Addendum No. 1

Bid Opportunity: 7159-RW-22 – Smithson PS Office and HVAC Upgrades.

Closing Date: Monday, March 14th, 2022 2:00 PM

4 EXISTING ELECTRICAL SERVICE
E2 SCALE: 1:200

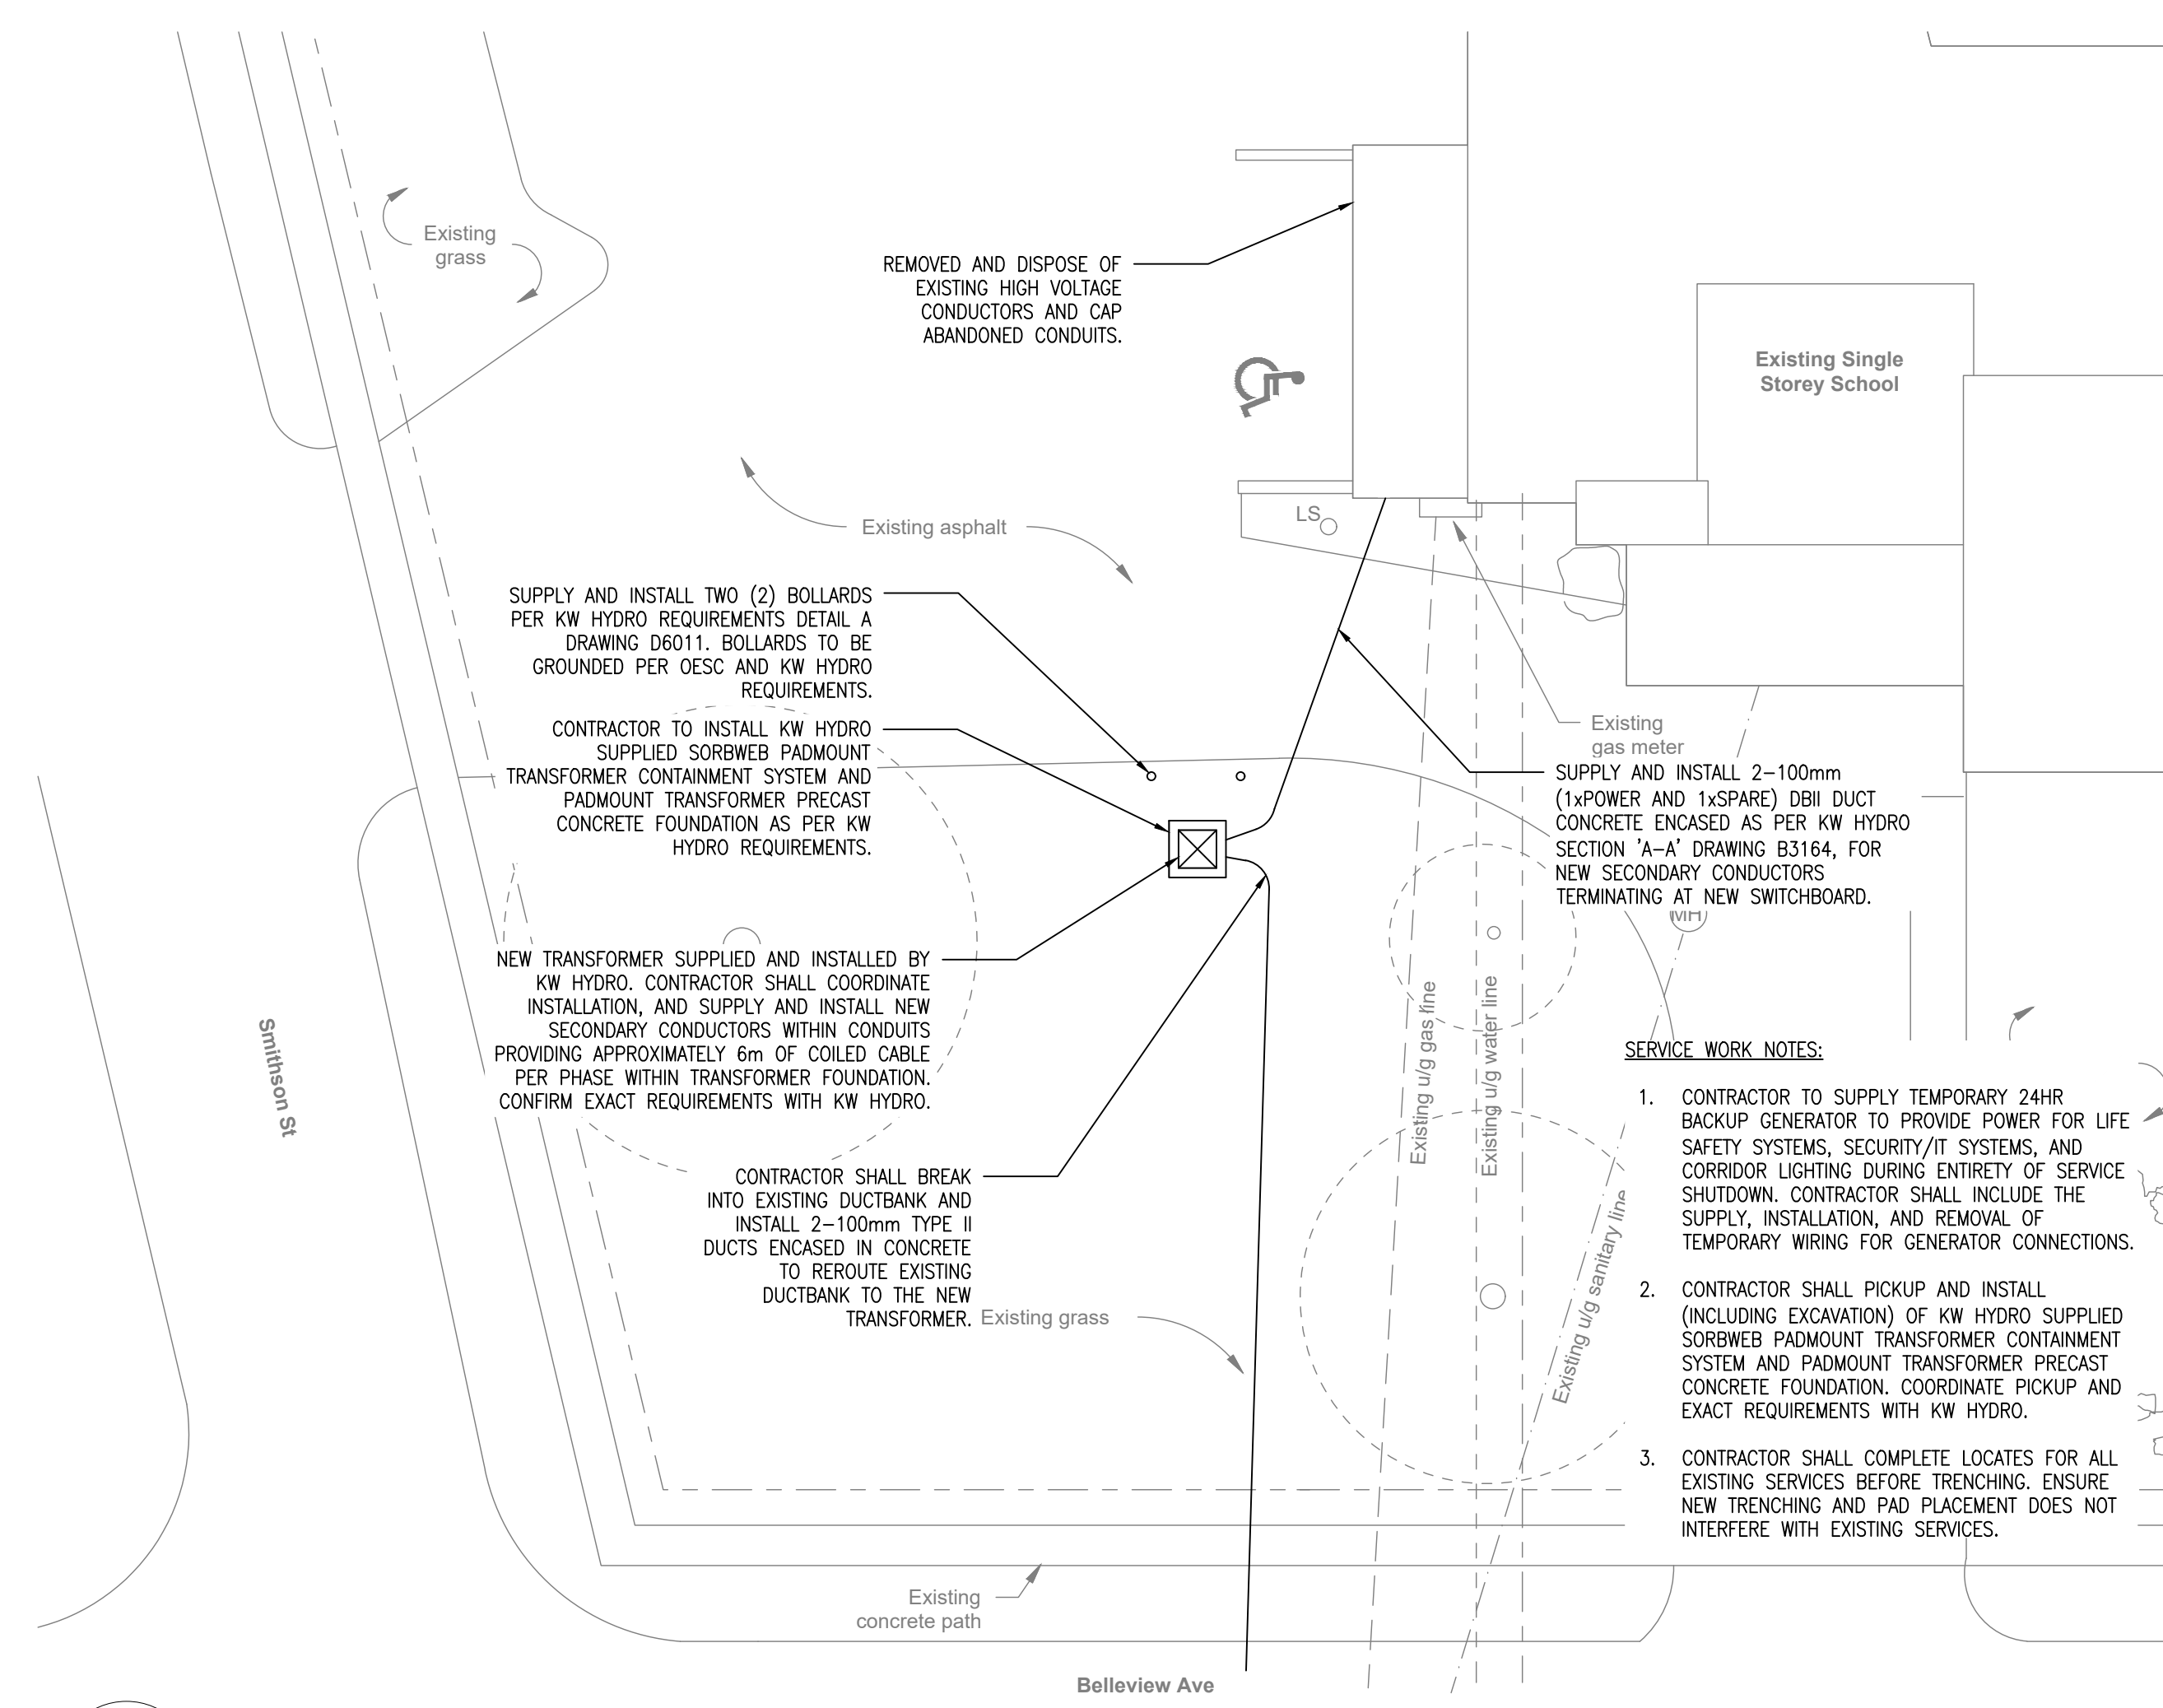
**3. REFERENCE DRAWING E2 – ELECTRICAL SINGLE LINE DIAGRAM AND
SITE PLAN (ISSUED FOR ADD-E01)**

1. The demolition of the existing ‘LP-2’ panel has been removed from the scope of work. The panel is existing to remain and the contractor shall revise the circuit breakers within the existing panel to suit new loads as per the updated panel schedule. Remove and dispose of obsolete breakers and supply and install new circuit breakers as required.
2. The new 100A,208V,3P switch within the existing 208V switchboard has been revised to feed the new panel ‘LP-4’. The supply and installation of one (1) new 100A,208V,3ph,4W panel ‘LP-4’ has been added. Refer to drawings for additional information and panel schedules. Supply and install new circuit breakers as required. Note 7 has been revised to indicate the revised scope of work.
3. Some of the devices fed from LP-2 have been revised to be fed from LP-4. Refer to updated panel schedules for more information.

5 EXISTING/DEMO PLAN - CLASSROOM 14
E3 SCALE: 1:50

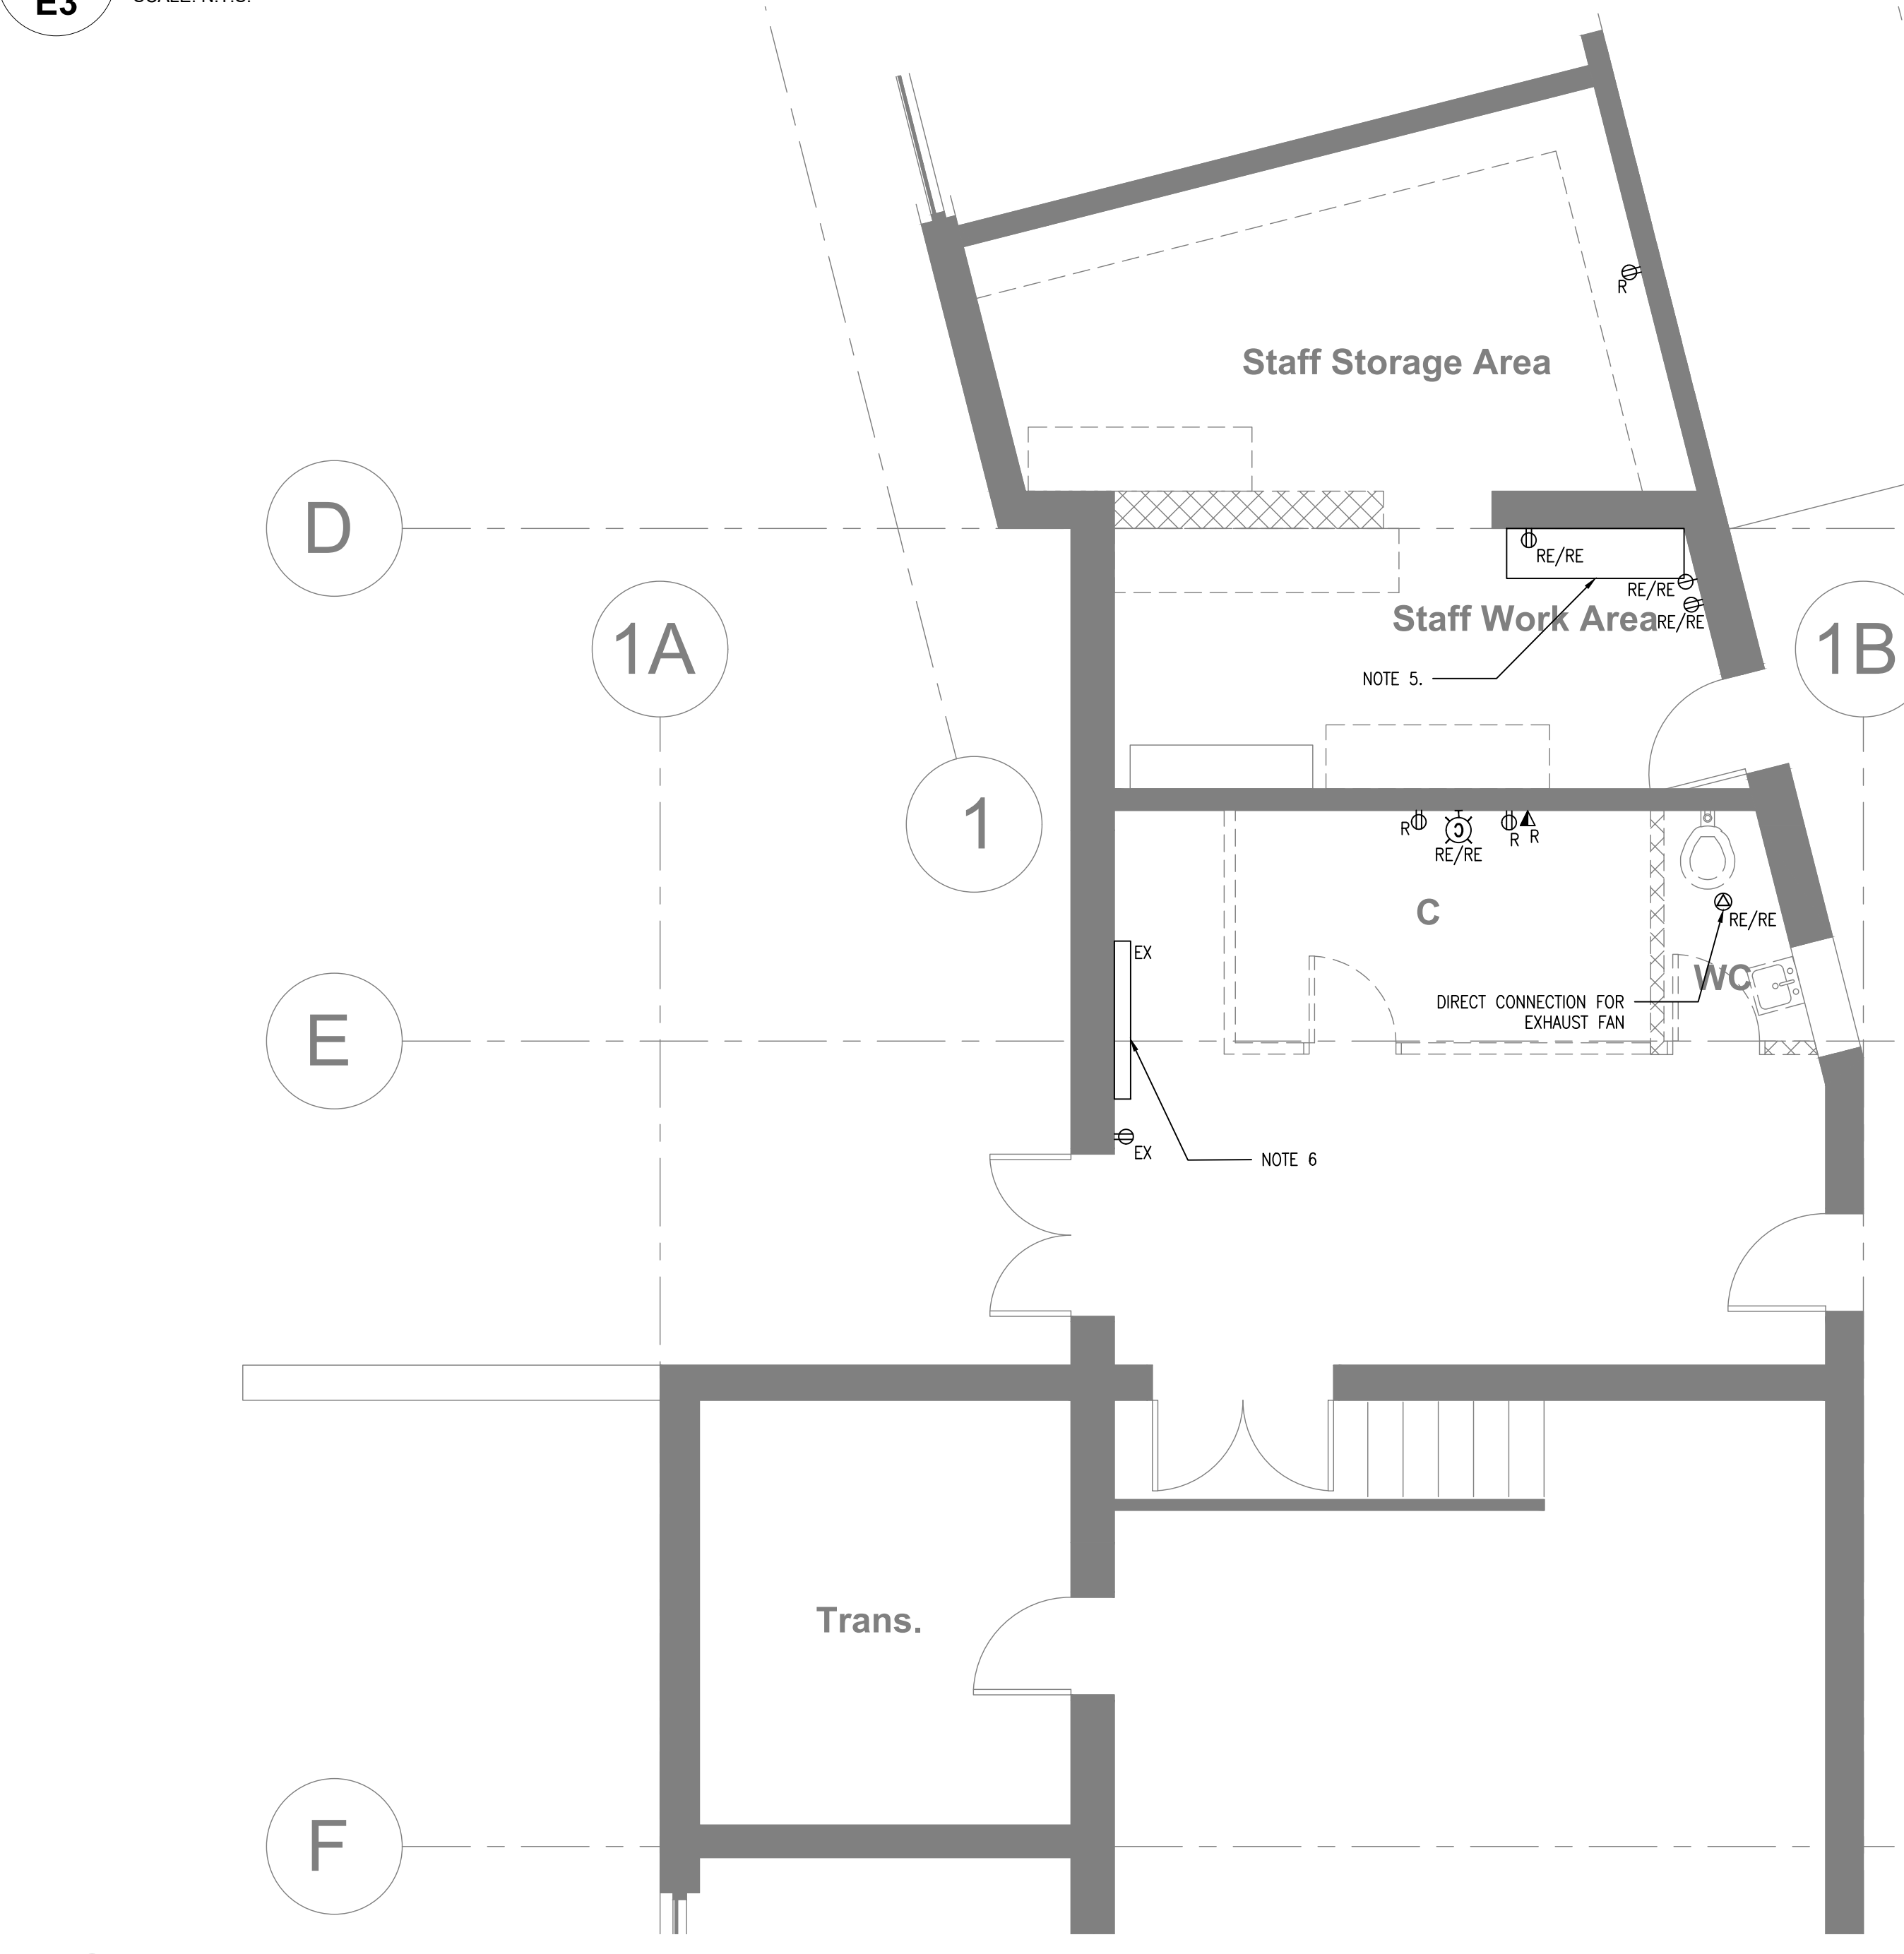
1. An existing IT Hub cabinet and cabling shall be relocated to facilitate the installation of the new bulkhead within Classroom 14. Refer to detail 8/E11 for more information. Extend or revise all data and power cabling as required. Final location to be approved by WRDSB.
